**NUMBER:** 18-087-16 REV. A

#### SUBJECT:

Engine Oil Viscosity Upgrade And Flash Enhancements

2016	(WK)	Jeep Grand Cherokee
**2016	(DS)	Ram 1500 Pickup**

Fig. 1 Cap Before Sticker Applied

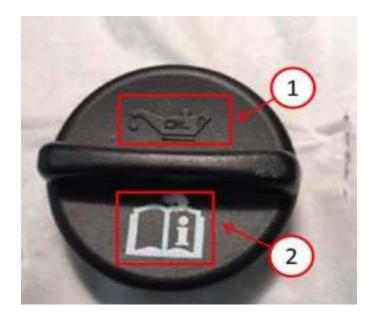
- 6. Remove oil fill cap.
- 7. Clean top of oil fill cap with Isopropyl alcohol or equivalent and apply engine oil viscosity rating sticker as shown in (Fig. 1).

- 1 Do Not Cover This Embossed International Oil Symbol
- 2 Cover This Old Oil Info Symbol With The New "5W40" Label

Fig. 2 Damaged Rubber Seal

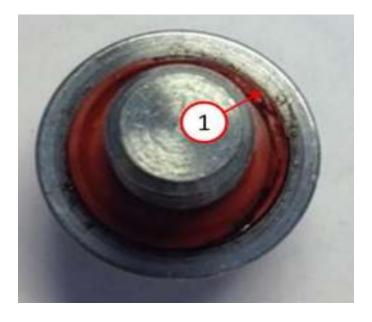
- 8. Remove the oil drain plug and allow oil to drain for at least 5 minutes or until it stops dripping.
- 9. Inspect the oil drain plug and gasket for damages (Fig. 2). Replace if necessary.

1 - Oil Drain Plug Gasket Seal Crushed

- 10. Reinstall the oil drain plug. Tighten to 45 N·m (33 ft. Lbs.).
- 11. Add 5W-40 synthetic engine oil to the engine. Use 10 quarts for (DS) Ram trucks and 8 quarts for (WK) Jeep Grand Cherokee. Take care not to spill oil on engine.
